APPLICATION NO.	FILING DATE	FIRST NAMED INVENTOR	ATTORNEY DOCKET NO.	CONFIRMATION NO.
10/511,119	03/17/2005	Patrice Cardine	60130-2246	8871
26096 7590 12/11/2008 CARLSON, GASKEY & OLDS, P.C. 400 WEST MAPLE ROAD			EXAMINER	
			REDMAN, JERRY E	
SUITE 350 BIRMINGHAN	1, MI 48009		ART UNIT	PAPER NUMBER
			3634	
			MAIL DATE	DELIVERY MODE
			12/11/2008	PAPER

Application No.	Applicant(s)			
	10/511,119	CARDINE ET AL.			
Office Action Summary	Examiner	Art Unit			
	Jerry Redman	3634			
The MAILING DATE of this communication app Period for Reply	pears on the cover sheet with the o	correspondence address			
A SHORTENED STATUTORY PERIOD FOR REPLY WHICHEVER IS LONGER, FROM THE MAILING DA - Extensions of time may be available under the provisions of 37 CFR 1.13 after SIX (6) MONTHS from the mailing date of this communication. - If NO period for reply is specified above, the maximum statutory period v - Failure to reply within the set or extended period for reply will, by statute, Any reply received by the Office later than three months after the mailing earned patent term adjustment. See 37 CFR 1.704(b).	ATE OF THIS COMMUNICATION 36(a). In no event, however, may a reply be tilused and will expi

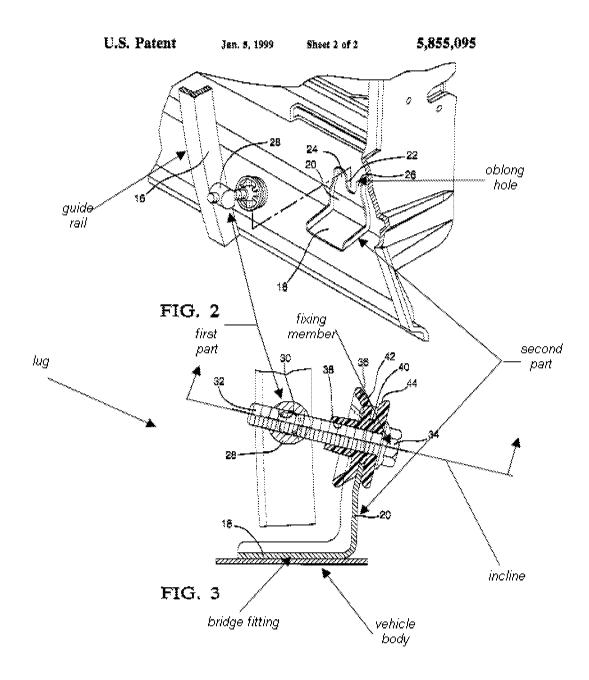
As best understood, claims 1-23 are rejected under 35 U.S.C. 102(b) as being anticipated by Dedrich et al., (5,855,095). As shown in detail below, Dedrich et al., (5,855,095) disclose having a first "twisted"/bent part connected to a guide rail which moves a window pane between an open and closed position, a second "planar" part fixed to the vehicle body (at 18) and having an oblong hole (22) for passage of a fixing member (34), and a bridge fitting (see figure below). Furthermore, since the guide rail is

curved and the window opening and closing path is curved (i.e., guiding direction), then the second part defining a plane and a normal line is substantially perpendicular to the plane and inclined relative to the guiding direction.

The applicant's argument have been considered but are not deemed persuasive. The applicant argues that claim 1 now clearly defines the normal line is inclined relative to a window guiding direction. As stated in detail above, the window guiding direction is slightly curved so that there are many "normal lines" along the path of the window guiding direction. The applicant further argues that the first and second parts are a "single element" which is not readily understood by the Examiner as stated above. When the first and second parts of Dedrich et al. are attached together, they form a "single component". Still furthermore, the second part of Dedrich et al. is of an L-shape and therefore defines "two planes" and not just a single plane as recited in the applicant's arguments
